DEVELOPMENT REVIEW BOARD REPORT

Dual Drive-Thru Restaurants Pima Road 40-DR-2021	Request for approval of a site plan, landscape plan, and building elevations for two new drive-through restaurants on a +/- 1.5-acre site.
---	--

40-DR-2021

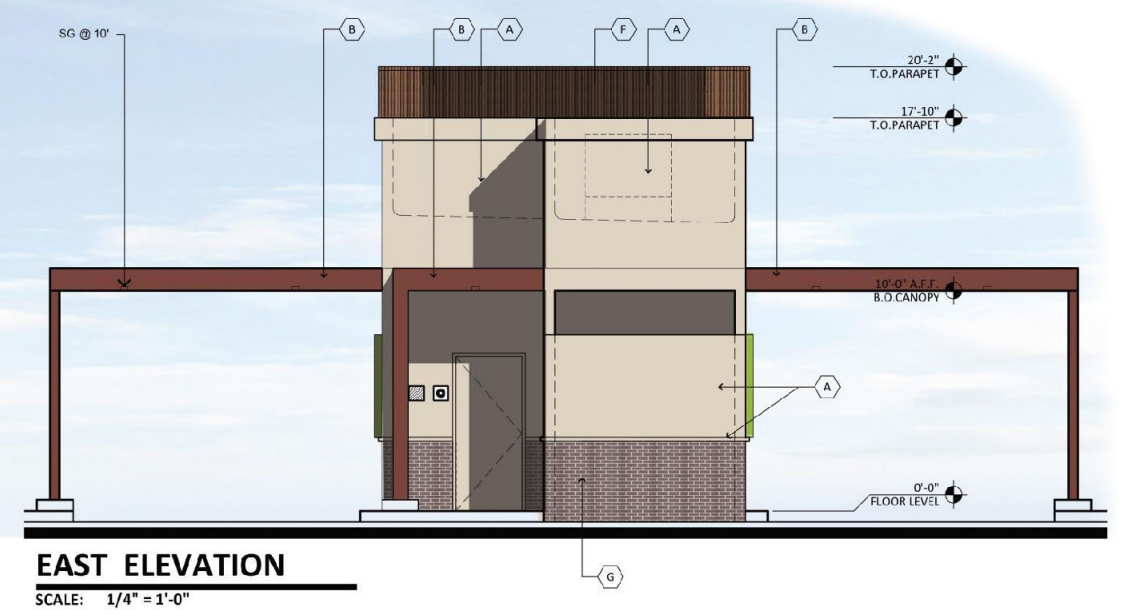
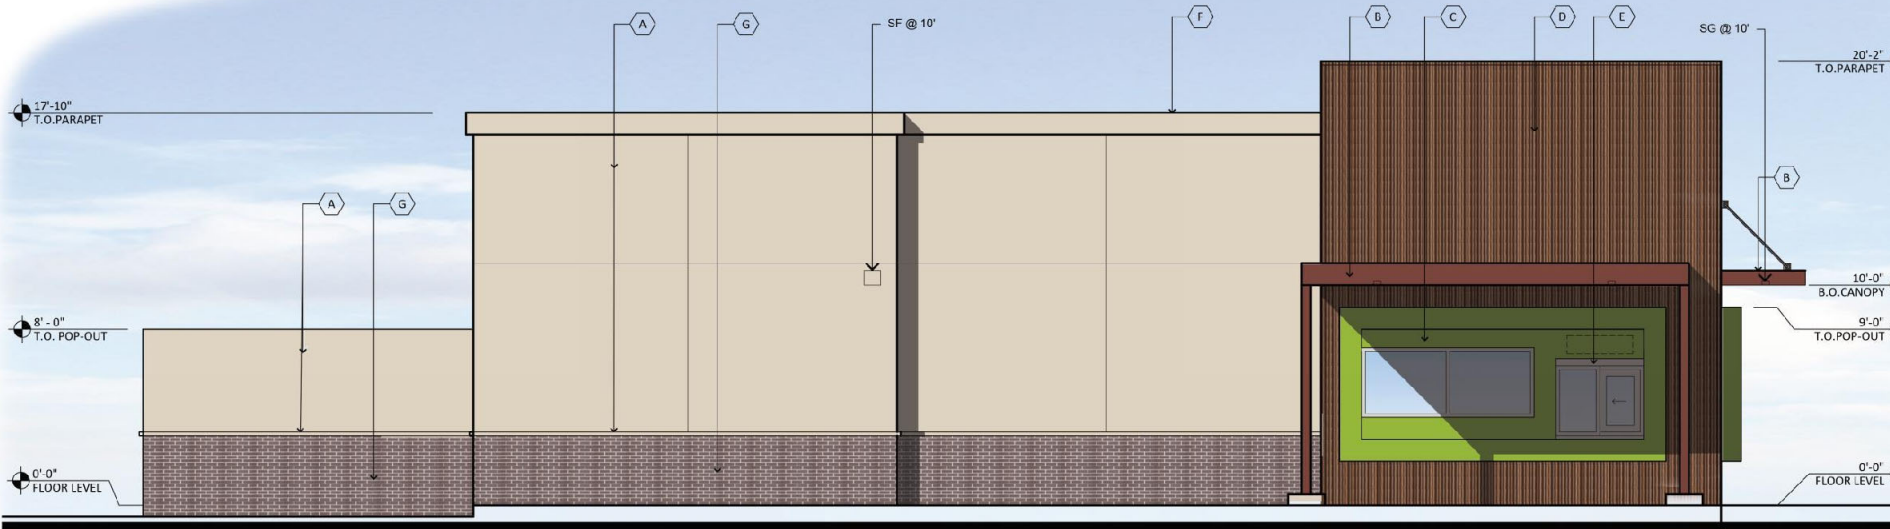
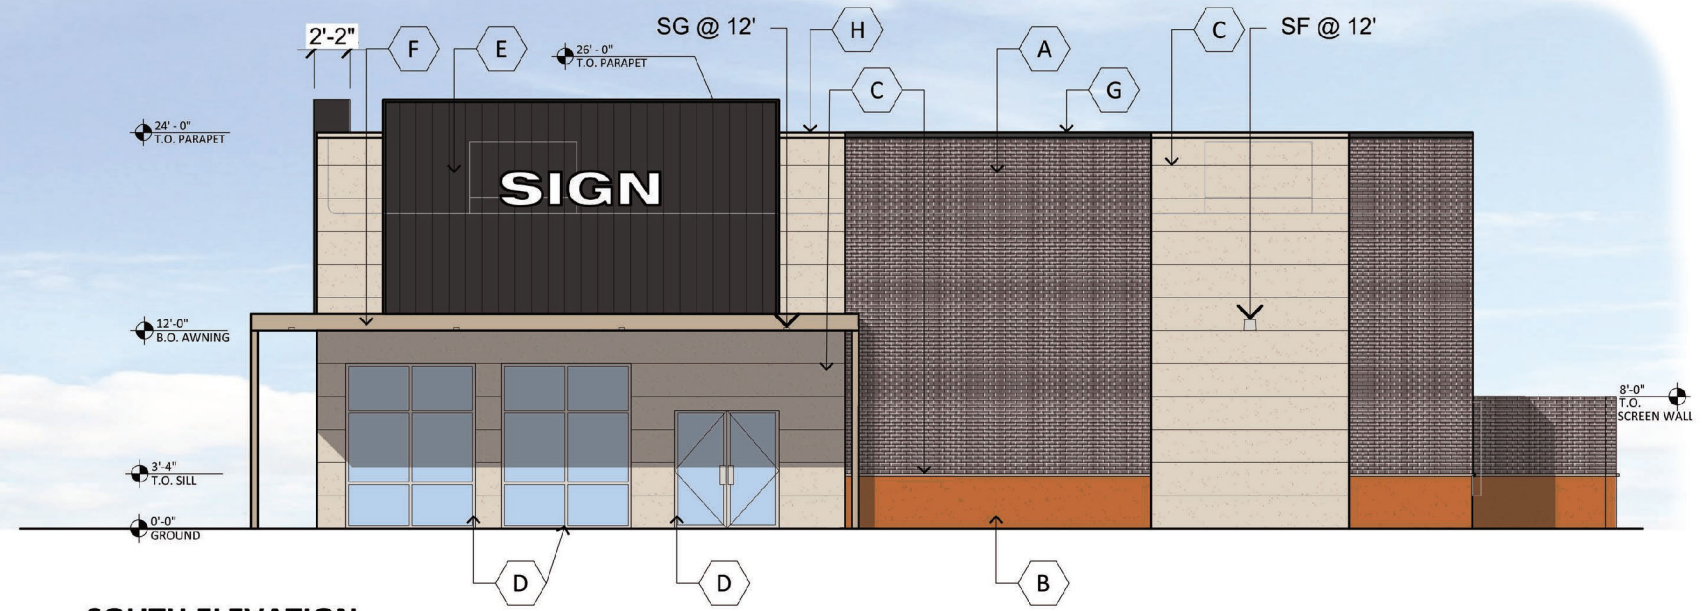
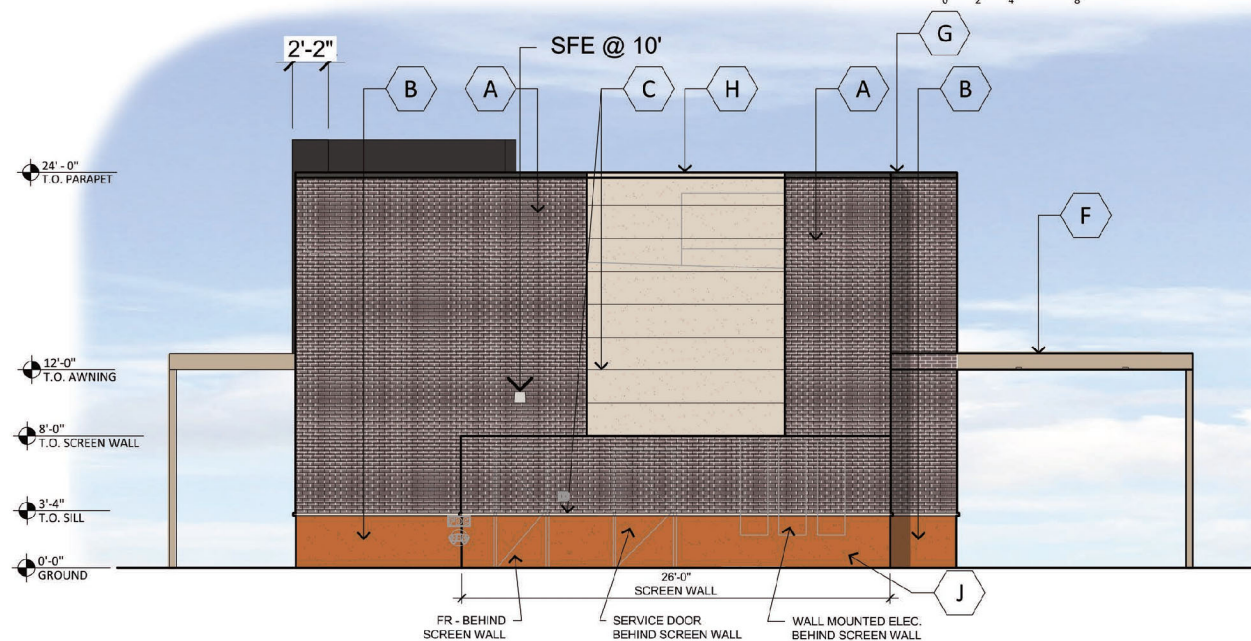
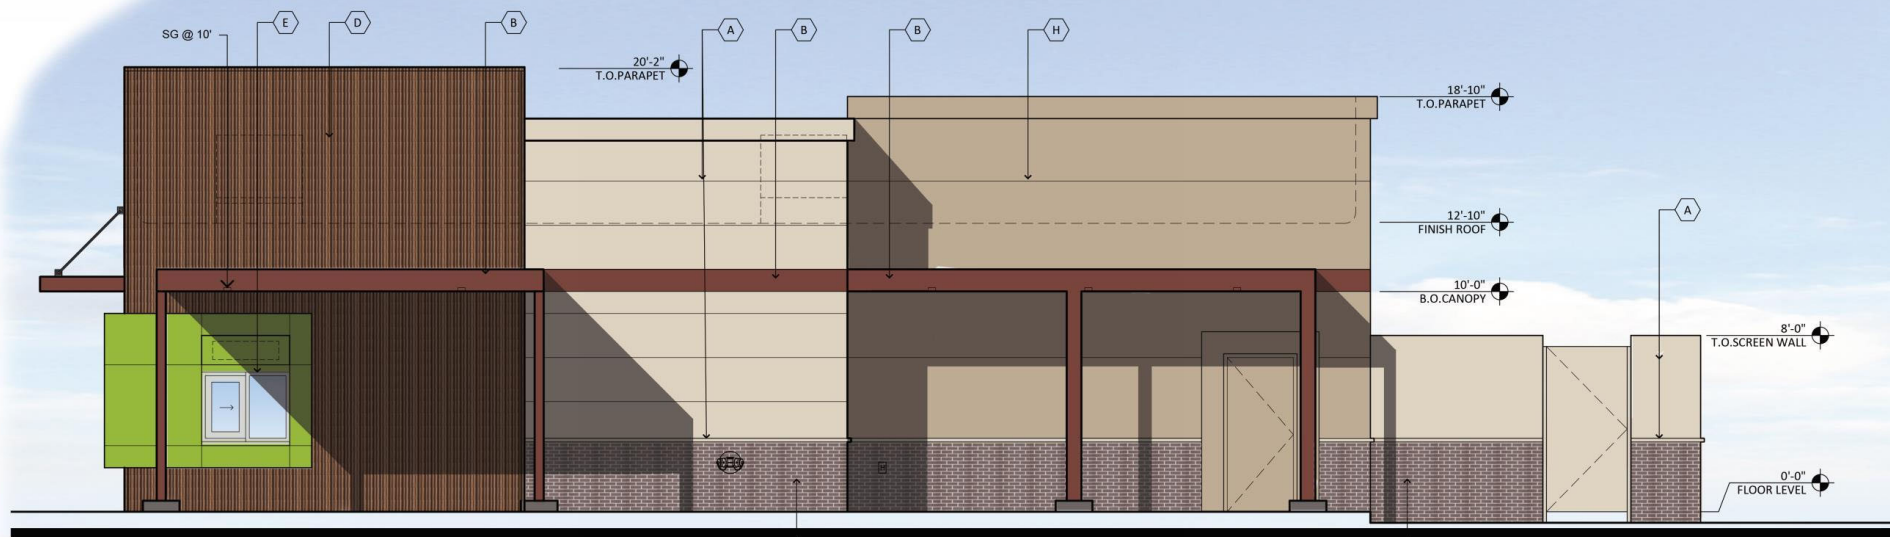
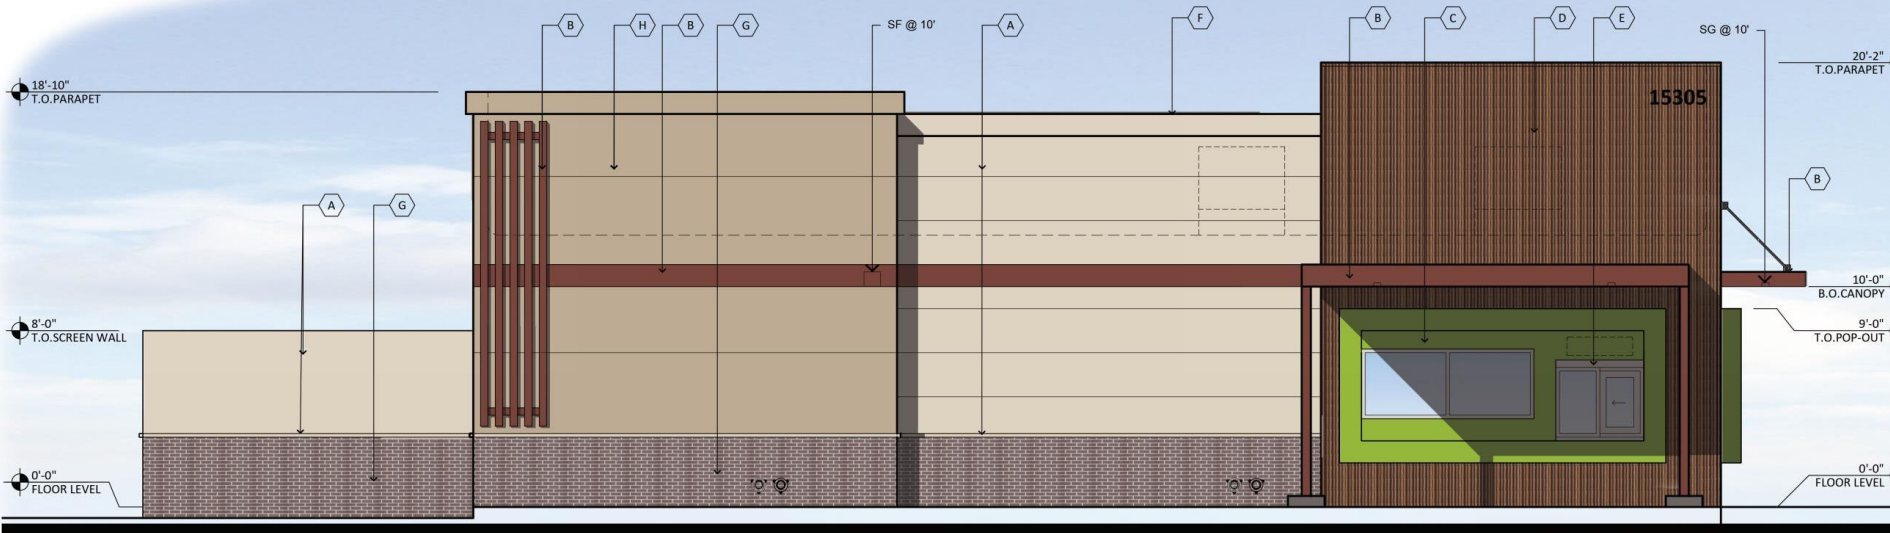
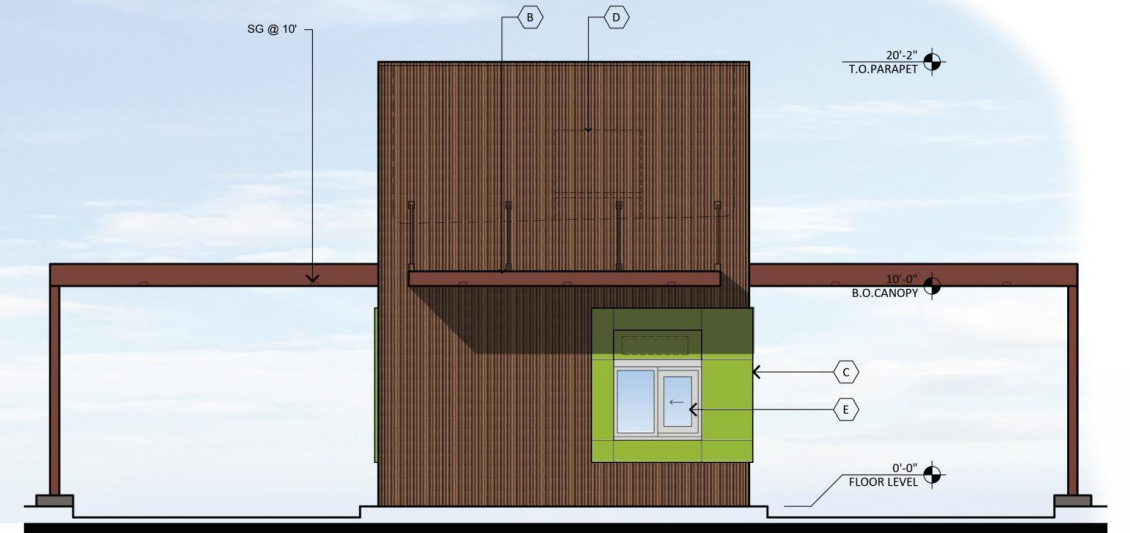
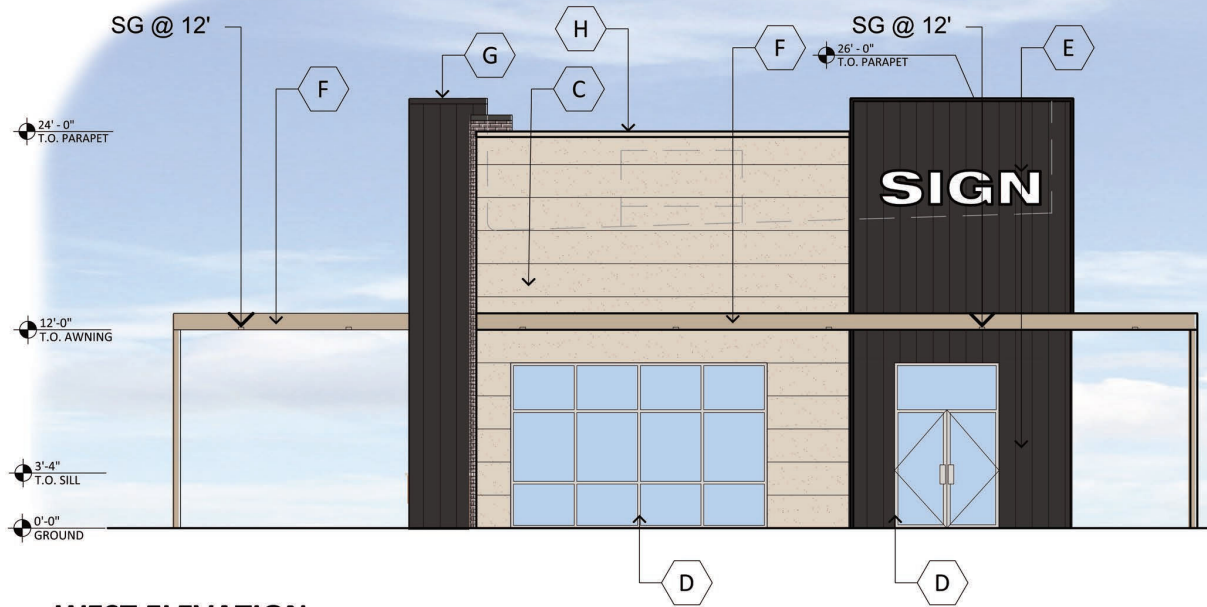
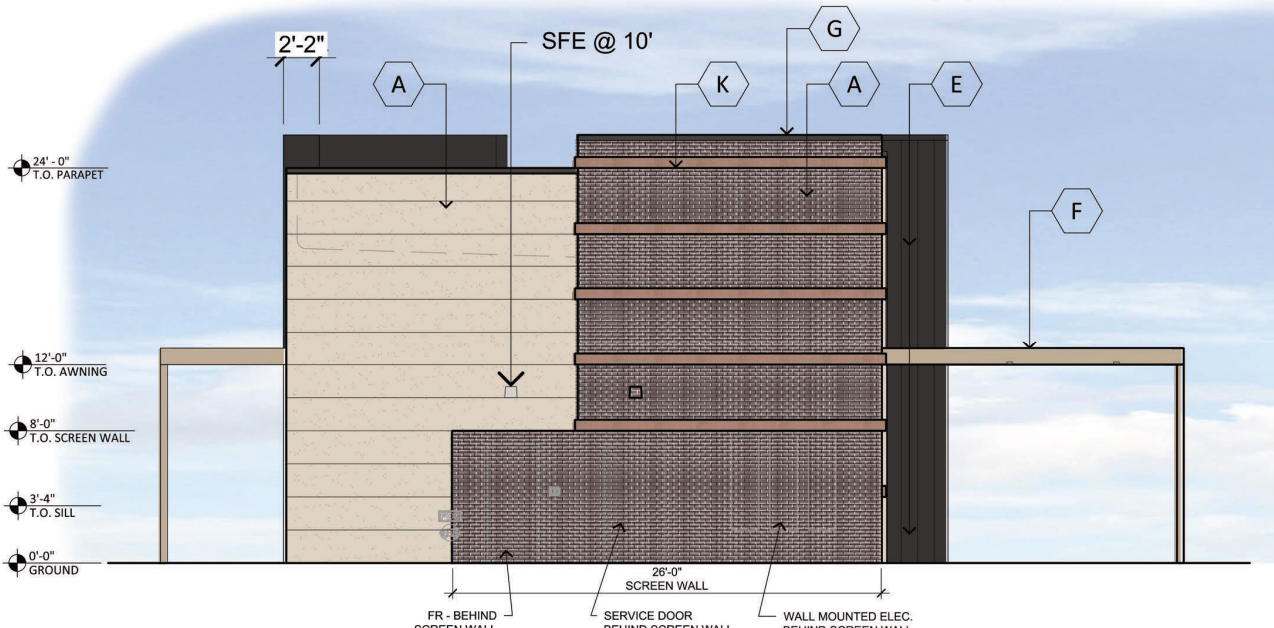
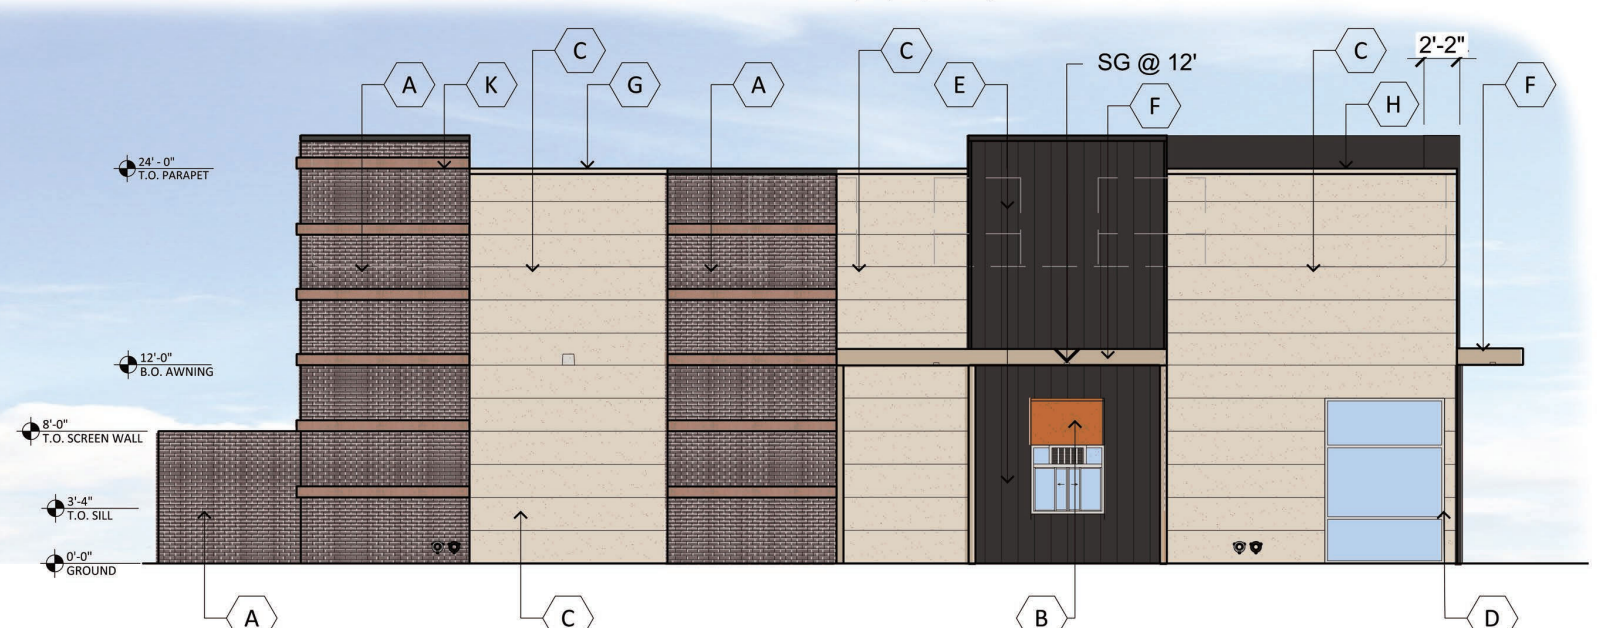
This case was continued at the [April 21, 2022 Development Review Board](#) meeting due to concerns the Board had with the north and east elevation of PAD A and overall traffic congestion in the area. Due to public visibility of the north and east elevation of PAD A to the freeway and internal private streets, the Board requested the lengthy north elevation be broken up and include more visual interest. The applicant has since revised the elevations of PAD A to include varied heights, an additional dark tan color to highlight the façade articulation, and rust corrugated metal panels along the east and north elevation of PAD A, which mimics the El Pollo Loco design to the north. The applicant also revised PAD B to architecturally combine the parapets on southwest corner of the building, extend the brick veneer to the bottom of the building, removing the orange stucco element, and added horizontal wood composite elements.

- *Since the hearing on April 21, 2022, the applicant revised PAD A to add height variation, corrugated metal accents, and color articulation along the north and east elevation. Additionally, the applicant revised PAD B to integrate the previously separate parapet elements along the southwest corner of the building, extend the brick veneer to grade, replacing the orange stucco accent, and incorporated horizontal wood bands.*

- *Staff finds that the applicant worked to revise the architectural design of both PAD buildings to further align with the Restaurant Design Guidelines. On PAD A, corporate colors were significant removed, desert colors and raw materials were added, and wall articulation was integrated into the design. On PAD B, parapet depths were increased,*

and massing was broken up. On both PAD buildings, drive-through canopy and posts were added over all drive-through lanes for architectural integration and shading. The canopies were increased in size as well to cover a car length.
